# 14160 STONE EAGLE PLACE

# GRADING, EROSION, & SEDIMENT CONTROL PLAN

EPC STORMWATER REVIEW COMMENTS  
IN ORANGE BOXES WITH BLACK TEXT

PCD FILE NO. **CDR2119**

SITE MAP  
SCALE: 1"=50'

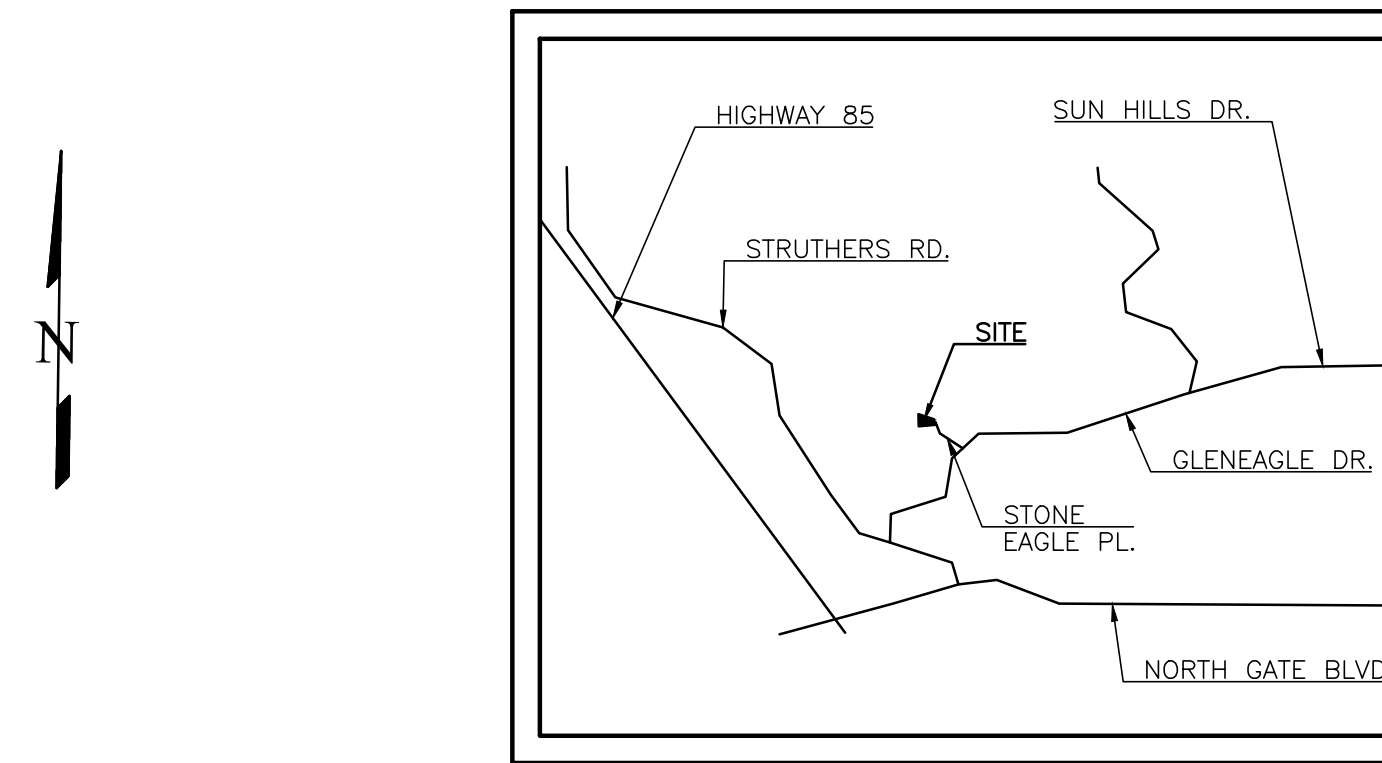
Item "i" - make a note about existing vegetation (in this case, the pre-disturbance vegetation).

Item "u" - make a note that locations of staging and stockpiles to be noted by contractor (if this is true, otherwise modify that statement as needed).

GRADING, EROSION, & SEDIMENT CONTROL PLAN  
EROSION CONTROL PLAN

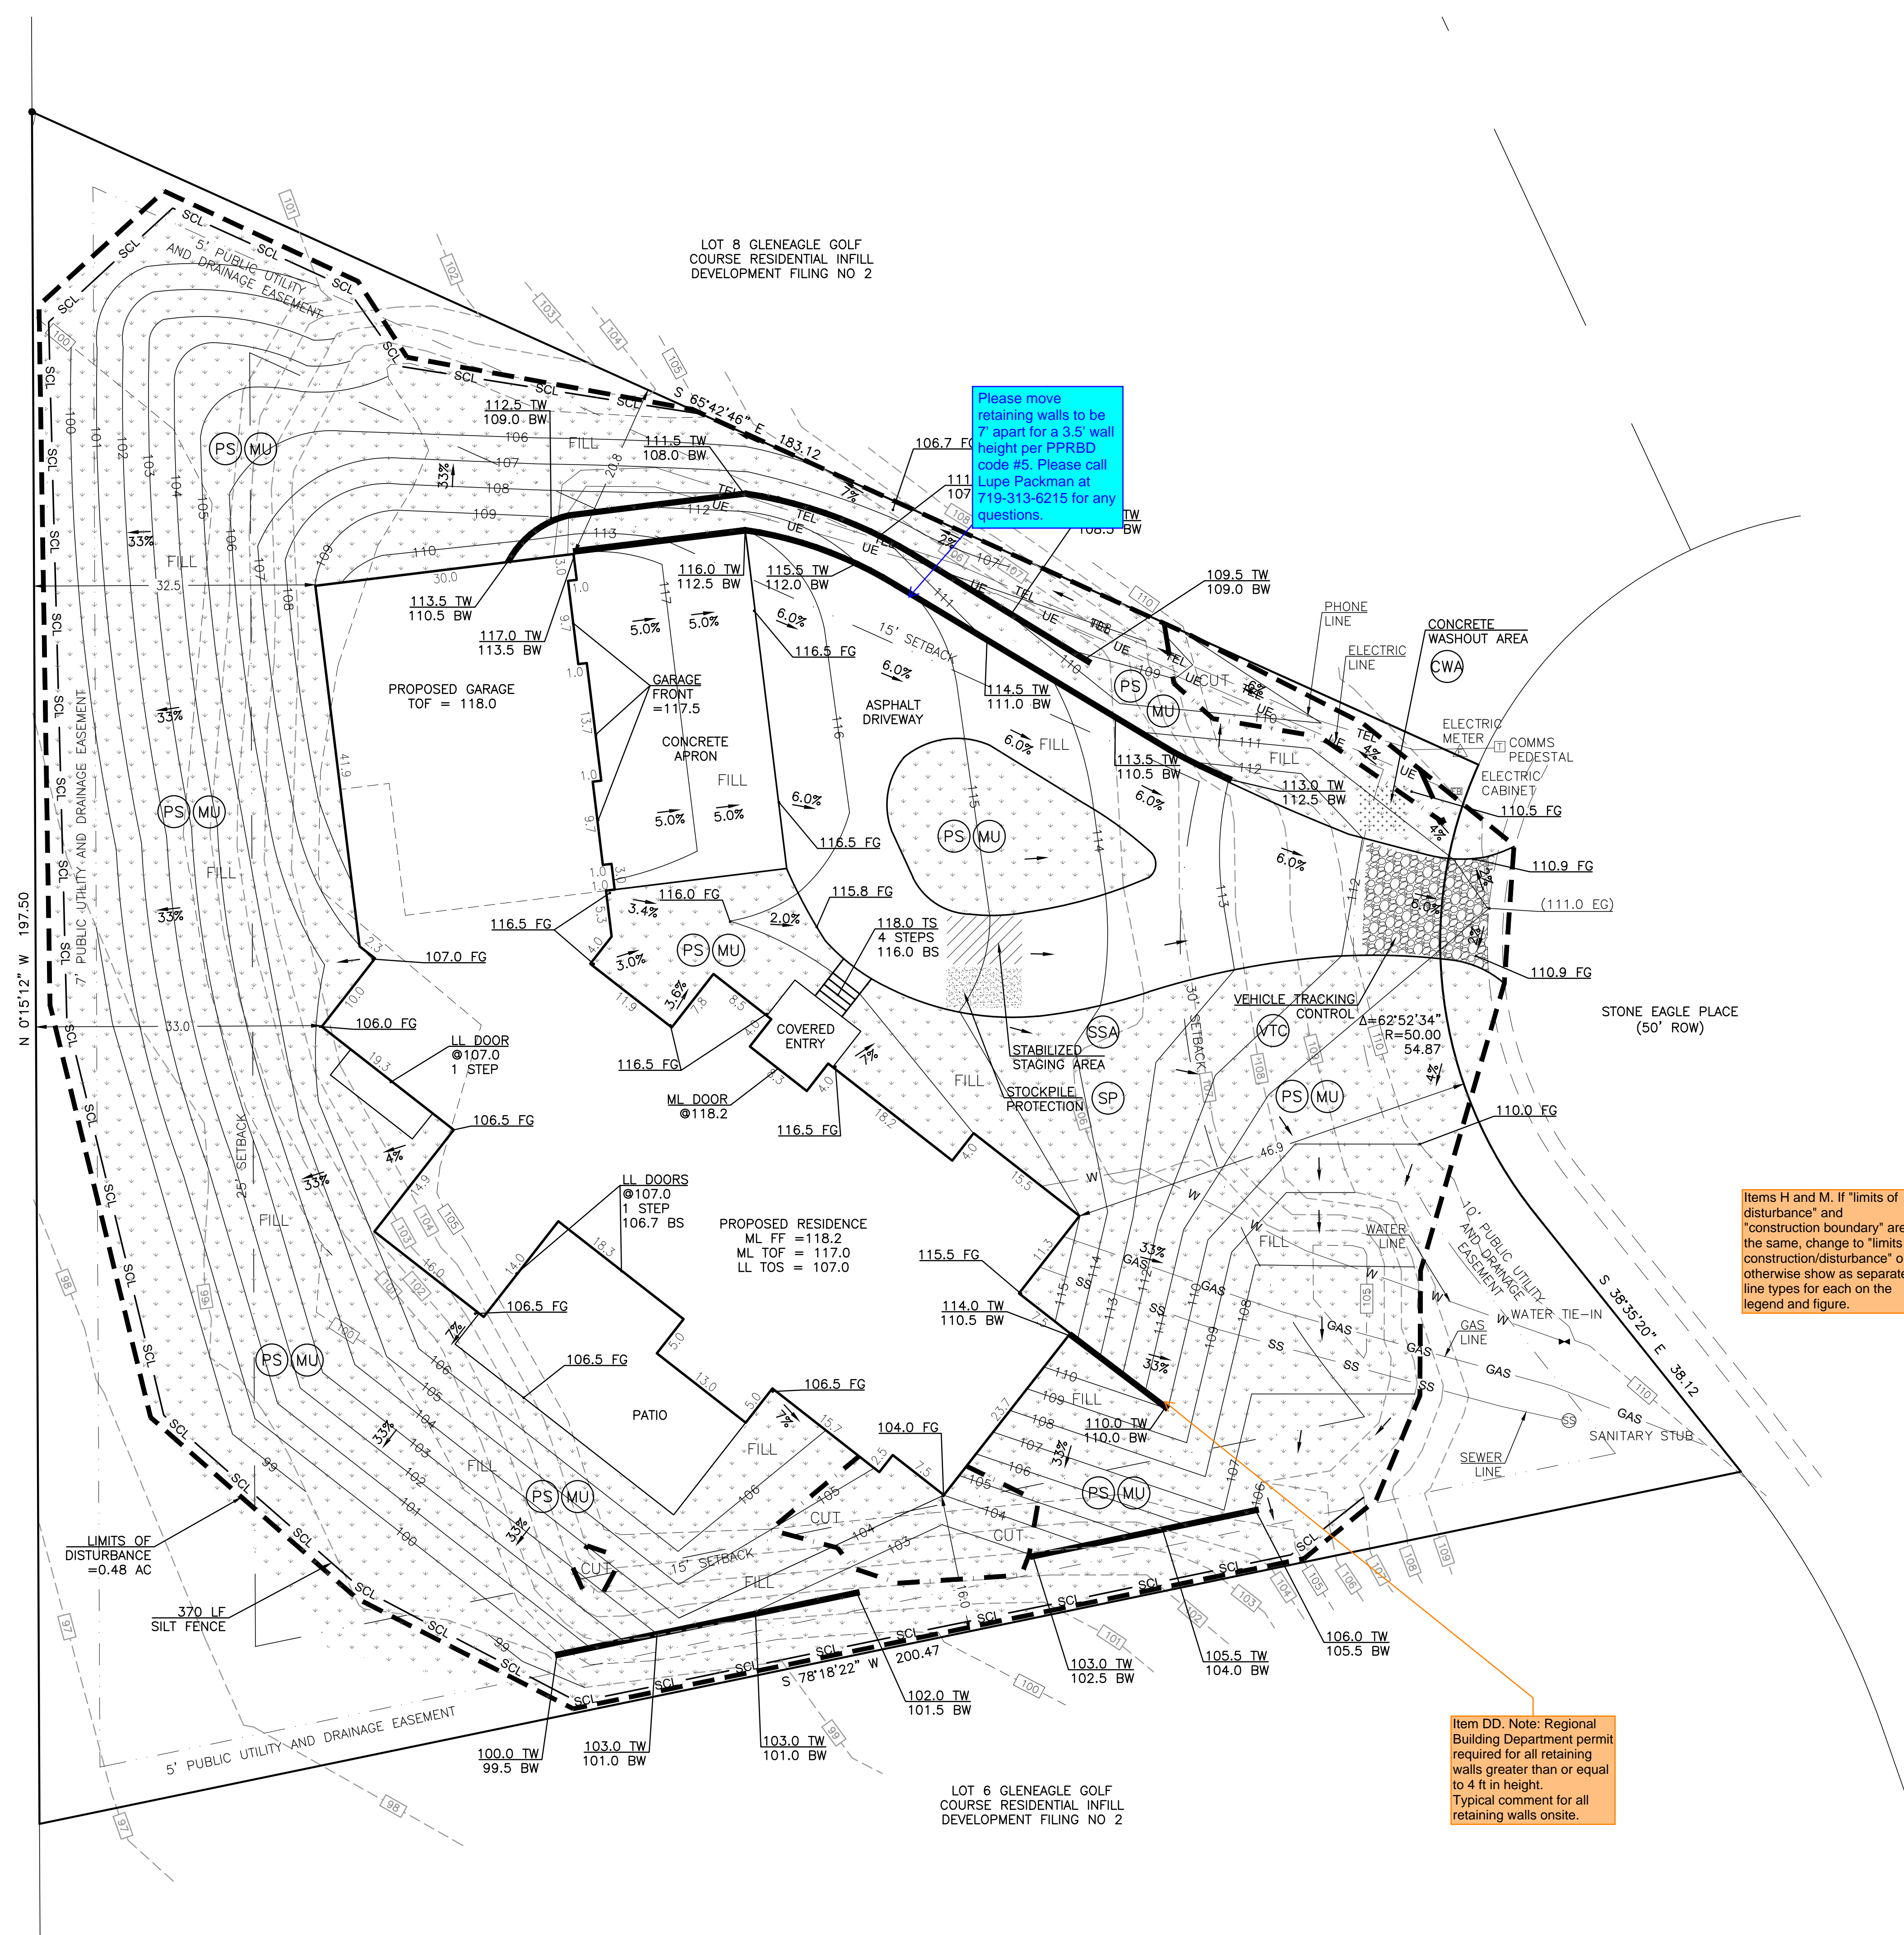
Please move retaining walls to be 7' apart for a 3.5' wall height per PPRBD code #5. Please call Lupe Packman at 719-313-6215 for any questions.

Items H and M. If "limits of disturbance" and "construction boundary" are the same, change to "limits of construction/disturbance" or otherwise show as separate line types for each on the legend and figure.

Item DD. Note: Regional Building Department permit required for all retaining walls greater than or equal to 4 ft in height. Typical comment for all retaining walls onsite.
